From: [Roderick Campbell](#)
To: [IPCN Enquiries Mailbox](#)
Cc: [Mark Ogge](#); [Tom Swann](#); [RD](#); [Tony Shields](#)
Subject: Narrabri gas submission
Date: Friday, 21 August 2020 5:00:54 PM
Attachments: [image001.jpg](#)
[image002.jpg](#)
[P960_Submission on new Narrabri modelling \[Web\].pdf](#)

Fast and loose

Analysis of Santos's eleventh-hour Narrabri Gas Project documents

Figure 1: Production costs of 2C sources of gas supply in presented by Acil ALLEN

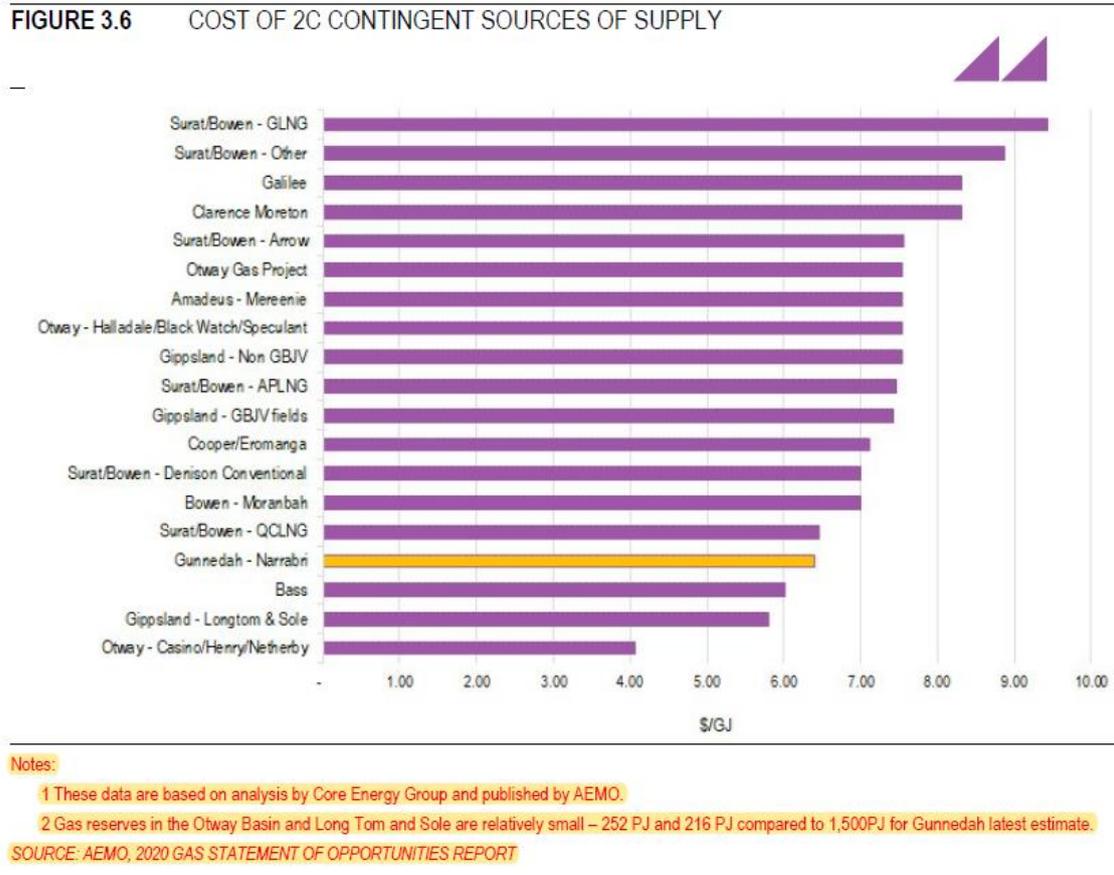
Figure 1 below shows production costs of various east coast and Northern Territory gas basins presented by ACIL Allen in the new economic report. Highlighted in the figure are the \$6.40/GJ production cost for the Gunnedah Basin, and ACIL Allen's presentation of this cost as an independent estimate by Core Energy and AEMO.

As shown in Figure 1, ACIL Allen implies that the production cost of \$6.40/GJ is an independent estimate by Core Energy Group in analysis commissioned by AEMO.

However, the \$6.40/GJ figure does not appear in the cited publication, AEMO’s 2020 *Gas Statement of Opportunities* (GSOO). Instead, Core’s production cost estimate for a number of gas basins including Gunnedah is a range of \$7.28-9.36/GJ, well above the \$6.40/GJ attributed to them by ACIL Allen, as shown in Figure 2 below:

Figure 4: Gas flows in ECGM August 2-8, 2020, TJ

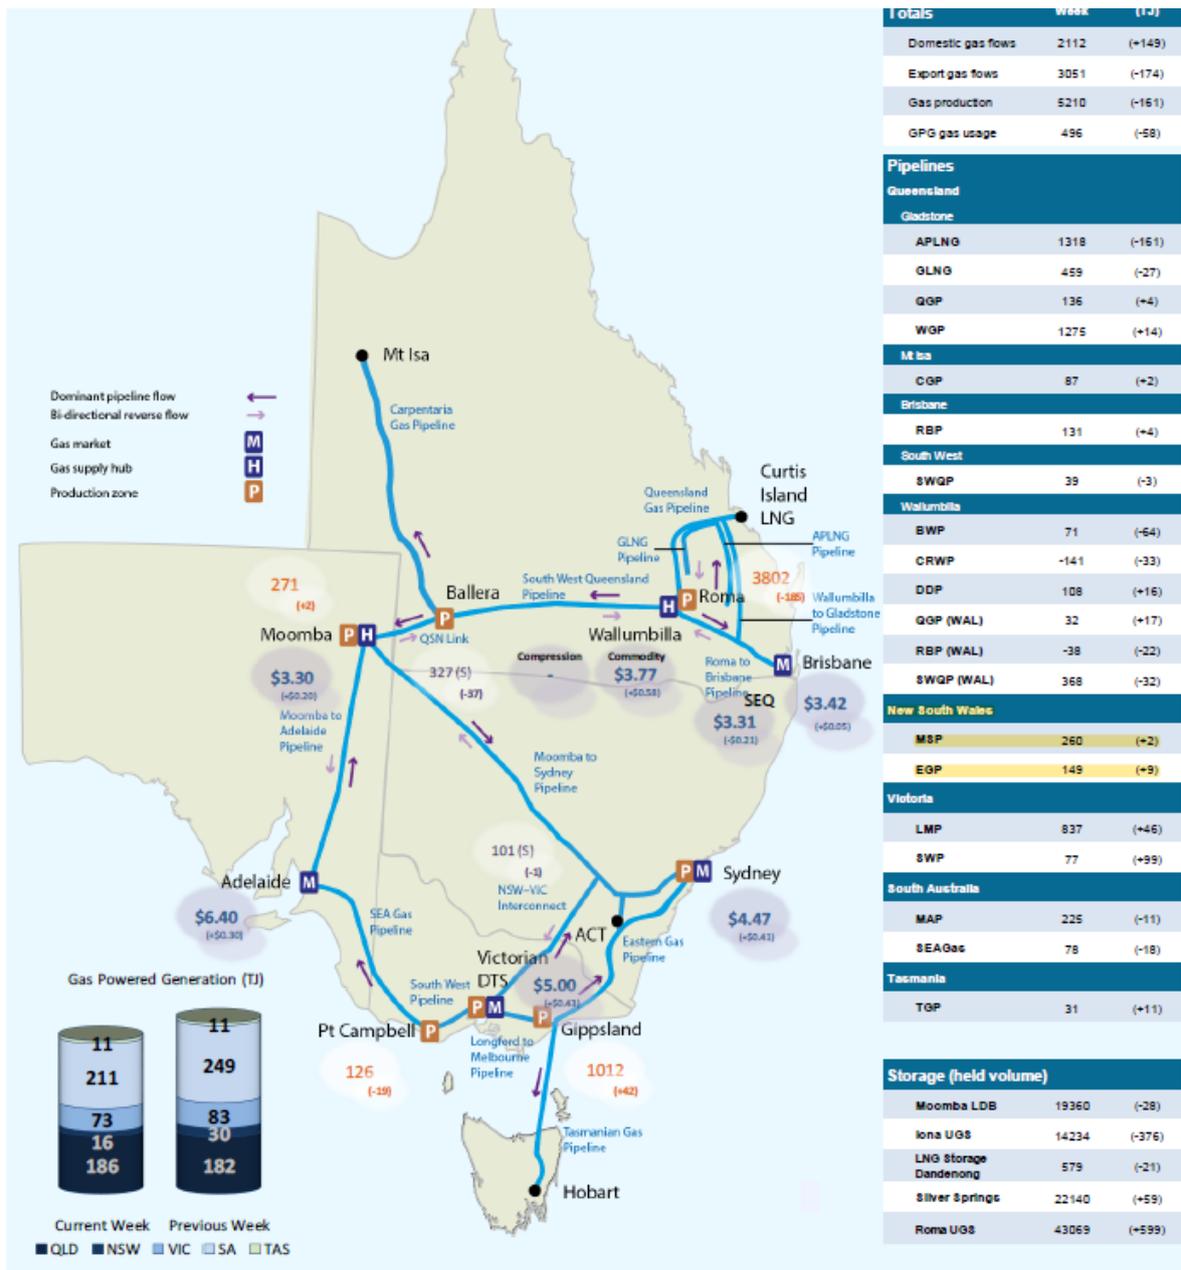
Figure 4 below shows the gas flows for the week 2-8 August 2020. The gas flows for NSW for that week, 64% (260 TJ) was supplied by the MSP from the Cooper Basin, with the remainder coming from Victorian fields via the EGP:

As shown in Figure 4, some of the gas coming to NSW via the MSP may be provided from Queensland CSG via the South West QLD Pipeline (SWQP) feeding into the MSP, but the SWQP flows are small in comparison to the volume of gas being delivered to NSW from the MSP. These gas flows vary from week to week, but the flows discussed above are fairly

Figure 5: Comparison of delivered cost of Cooper and Gunnedah basin gas to Sydney

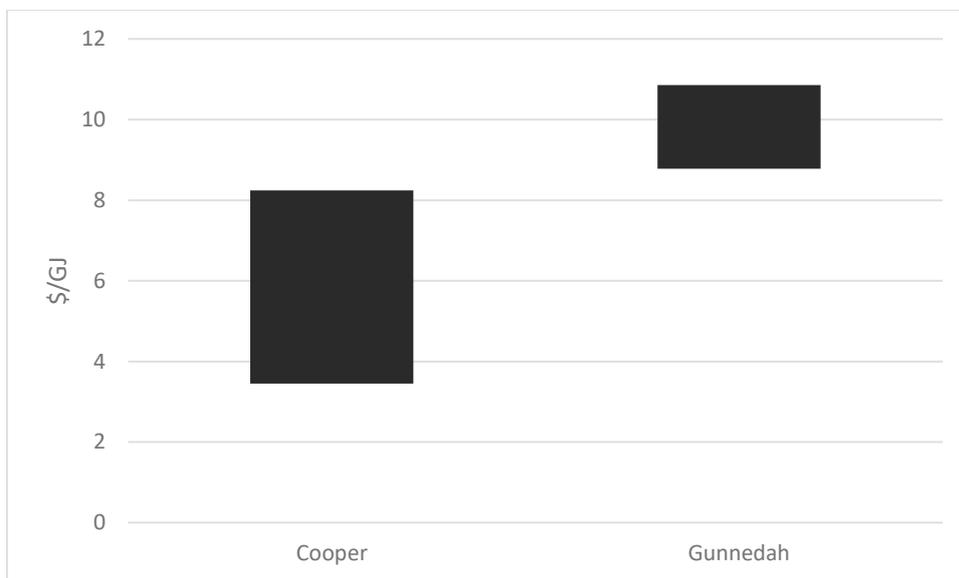
As shown in Table 2 and Figure 5 below, when both the production costs and transport costs are taken into account, the range of costs for gas delivered to Sydney from the Cooper Basin are \$3.56-\$8.24/GJ compared to \$8.78-\$10.86 for Narrabri. The lowest estimate for Narrabri gas is higher than the highest estimate for the gas from the Cooper Basin that it

Figure 7: Chart from Santos submission following IPC hearings comparing Narrabri cost to projected LNG import prices

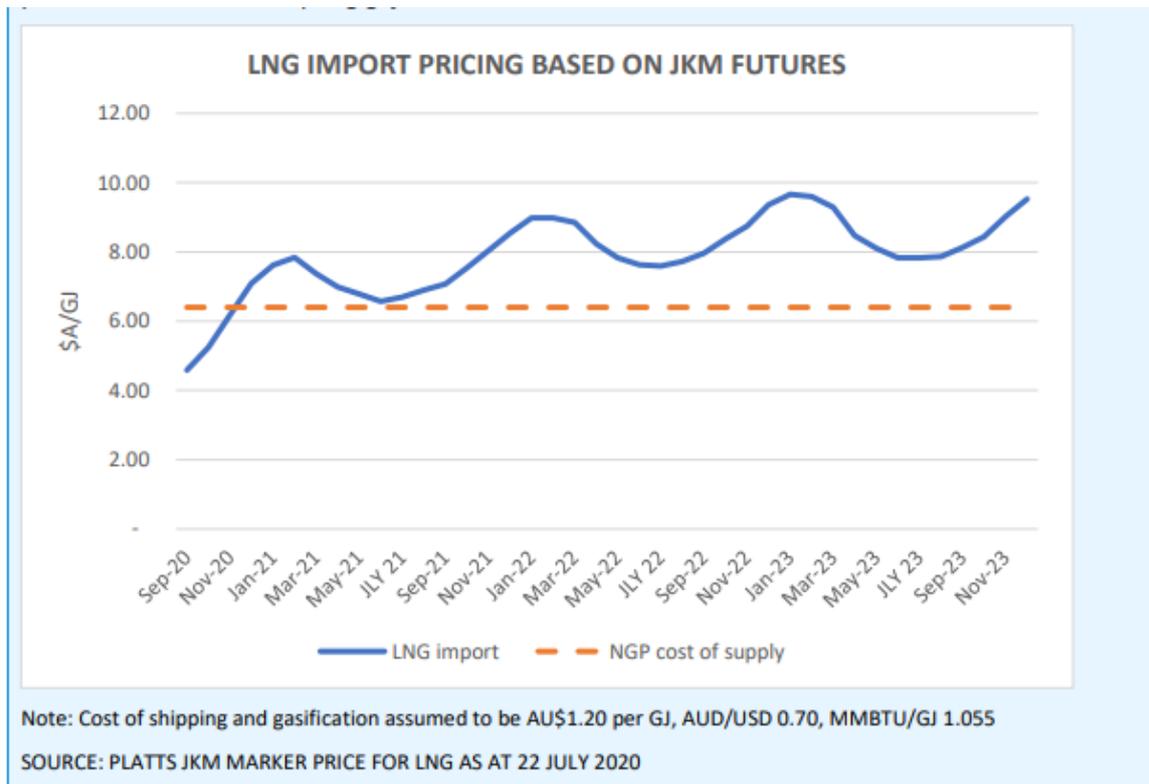
This graph is misleading for a number of reasons.

Figure 10: Santos oil price forecasts from annual reports

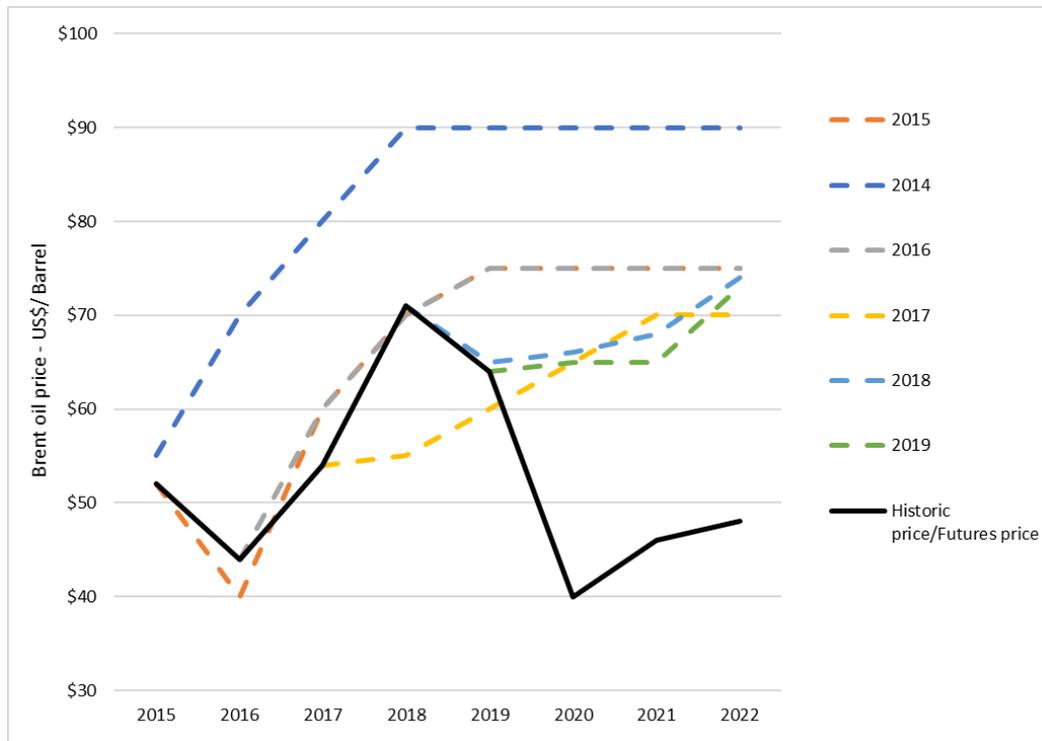
Table 3 above shows that Santos' estimates are optimistic more often than pessimistic. Just as noteworthy is the size of the over-estimations compared to the under-estimations. The fifteen optimistic price forecasts average \$22 above the eventual price. Across the five pessimistic price forecasts, the under-estimated averages just \$5. In Figure 10 below we

graph Santos’ oil price forecasts. The chart highlights that Santos forecasts are nearly always optimistic.

Figure 11: Extract from ACIL Allen analysis showing employment impact

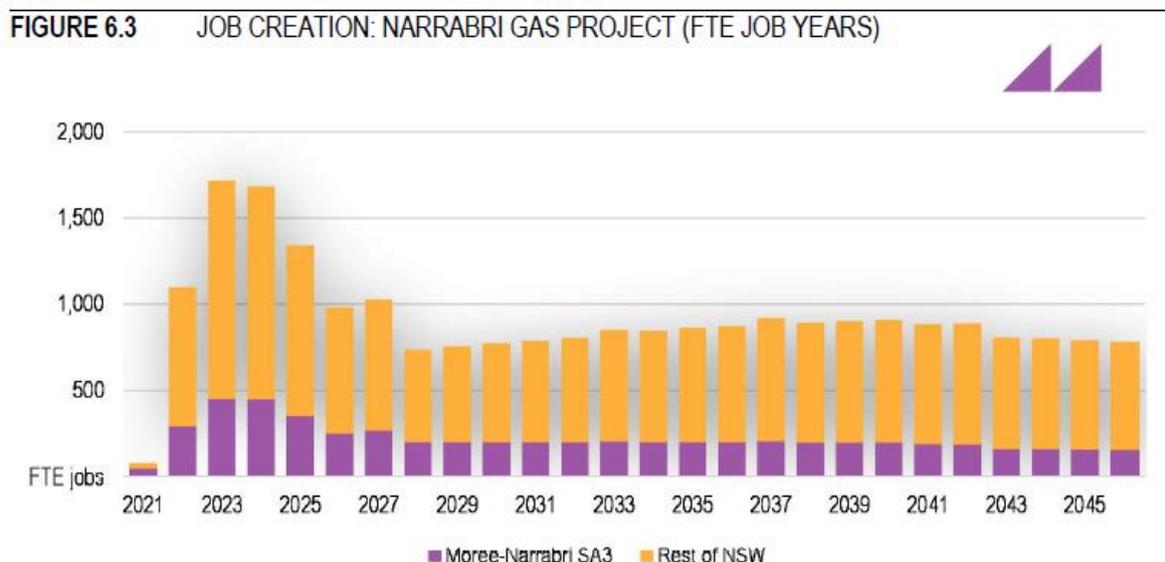
While it can be argued that in the middle of a pandemic it is appropriate to relax the full employment constraint, it is interesting that ACIL Allen’s figure 6.3 shows that the relaxation of this constraint is far from temporary, with post construction employment remaining higher out until at least 2046. This is shown in Figure 11 below:

Figure 19 Projected GPG generation across a range of reference years

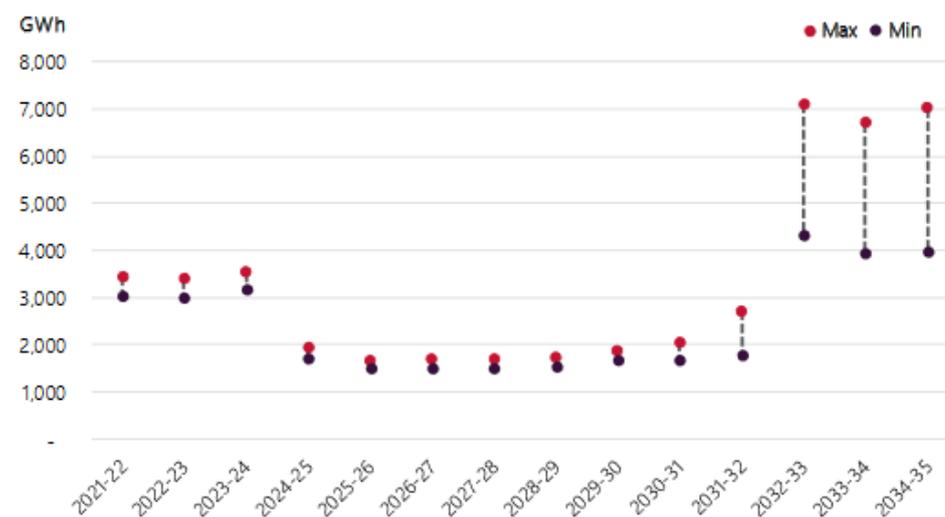
Crucially Santos completely ignores the clear conclusion of the AEMO ISP, that the optimal development of the NEM involves a lot more renewable energy, supported by storage, transmission and demand management, and a lot less gas-powered generation. Indeed this point is made *on the very same page* as the quote cited favourably by Santos - see highlighted sentences above highlighted paragraphs in Figure 12 below:

Figure 19 below shows how the energy produced by GPG may increase after significant coal retires post-2032, but that the variability of GPG across different weather reference years becomes much more volatile³⁵. Note that this analysis has been prepared to show the potential variability of gas demand. **The absolute values of gas generation in this chart are lower than currently observed in the market. This is because they have been derived by minimising total system cost, which optimally uses all available resources.** In practice, exceptional events (such as the recent islanding of South Australia), AEMO directions to maintain system security, contract positions and strategic bidding by generators can increase the level of gas usage by GPG and increase costs to consumers.

Figure 13: Gas vs renewables in the NEM – historical & AEMO ISP scenarios

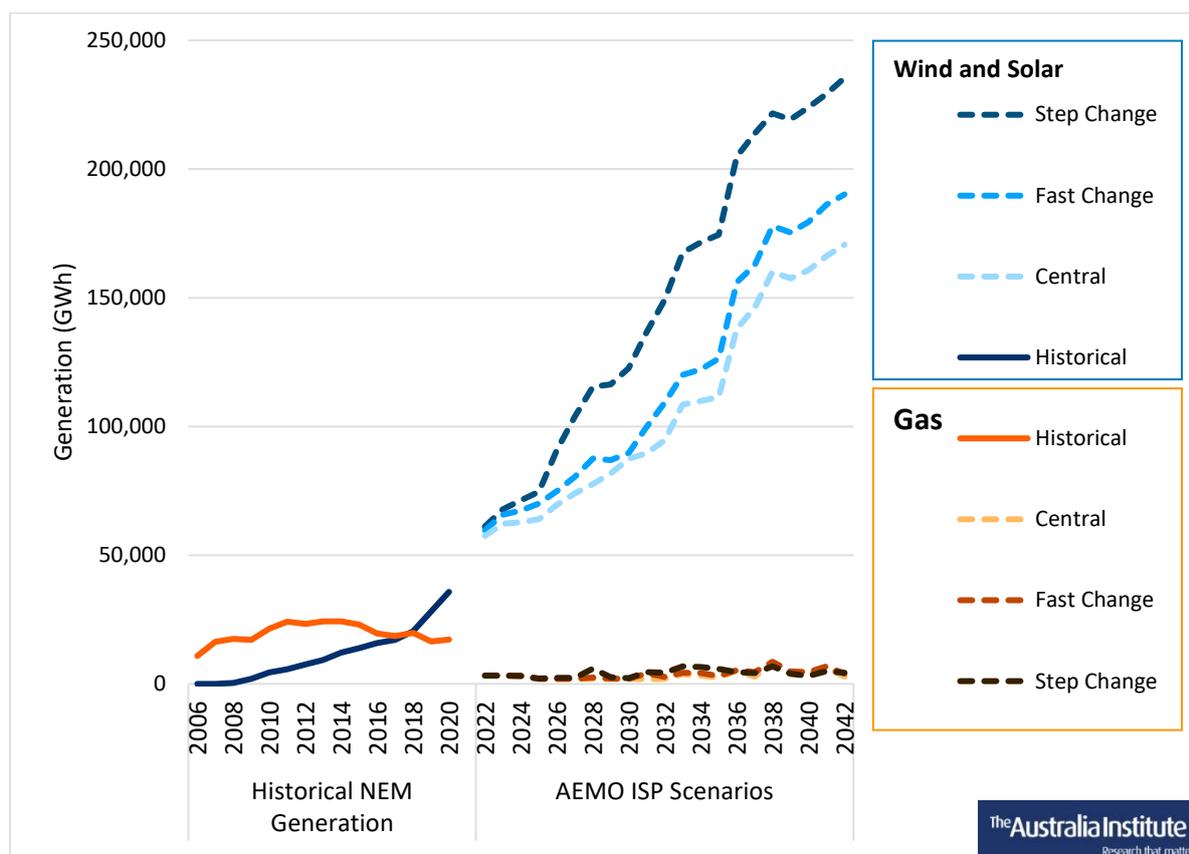
Santos ignore the fact that gas power generation in the NEM grew to mid-2010s, and has fallen since.⁶⁷ The AEMO ISP lowest cost scenarios show gas falling almost immediately and remaining low over coming decades. AEMO stresses these scenarios are “derived by minimising total system cost”. AEMO notes that “in practice” gas use may be higher for a range of reasons, like emergency events and “contract positions and strategic bidding by generators”, but adds where these factors increase gas generation they also “increase costs to consumers”.⁶⁸ By contrast with gas, renewable energy generation grows very strongly in each of these lowest cost scenarios, shown in Figure 14 below:
